# Access Compliance Report

## Public Rights-of-Way

### (Curb Ramps)

Intersection ID: 11325	Main Street: CARROWMORE_PL	Cross Street: THORNTON_RD	Location: NW
ADA ID: 779D32868AF8	Ramp Type: Perp	Initial Pass/Fail: Fail	Overall Compliance: No
		Severity Score: 8.75

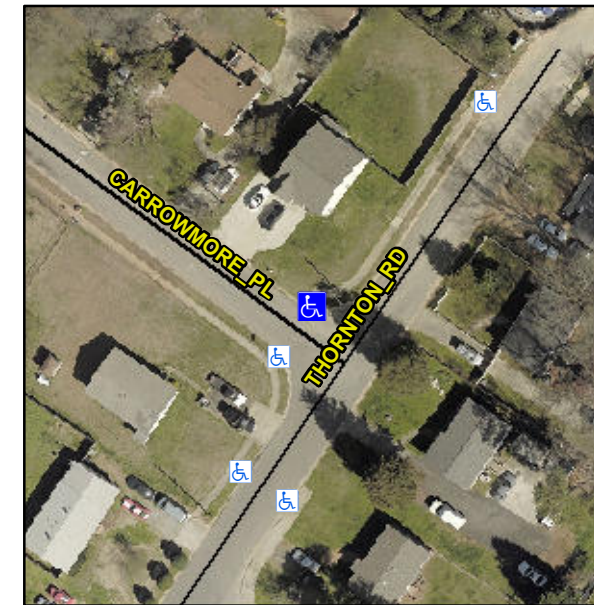
**Not Found, R304.5.1**

Compliance	Description	Data	Compliance	Description	Data
N/A	Ramp Length (in)	59.0	Yes	Ramp Slope (%)	5.5
No	Ramp Width (in)	47.0	Yes	Ramp XSlope (%)	0.5
N/A	Flare Type LT	N/A	N/A	Flare Type RT	N/A
N/A	Flare Slope LT (%)	N/A	N/A	Flare Slope RT (%)	N/A
N/A	Flare Traversable LT?	N/A	N/A	Flare Traversable RT?	N/A
N/A	Landing Length (in)	N/A	N/A	DWS Provided?	N/A
N/A	Landing Width (in)	N/A	N/A	DWS Contrast?	N/A
N/A	Landing Slope (%)	N/A	N/A	DWS Length (in)	N/A
N/A	Landing X Slope (%)	N/A	N/A	DWS Full Width?	N/A
N/A	Landing Curb? (Y/N)	N/A	N/A	DWS Offset (in)	N/A
N/A	Shared Landing?	N/A			
N/A	Gutter Ponding?	N/A	N/A	Gutter Slope (%)	N/A
N/A	Gutter Lip Ht (in)	N/A	N/A	Gutter X Slope (%)	N/A
N/A	Painted X Walk1?	No	N/A	Painted X Walk2?	N/A
	X Walk 1 Direction	To SW		X Walk 2 Direction	N/A
N/A	X Walk 1 Width (in)	N/A	N/A	X Walk 2 Width (in)	N/A
	X Walk 1 Slope (%)	2.7		X Walk 2 Slope (%)	N/A
	X Walk 1 X Slope (%)	0.7		X Walk 2 X Slope (%)	N/A

**Remove & Replace Entire Ramp.**
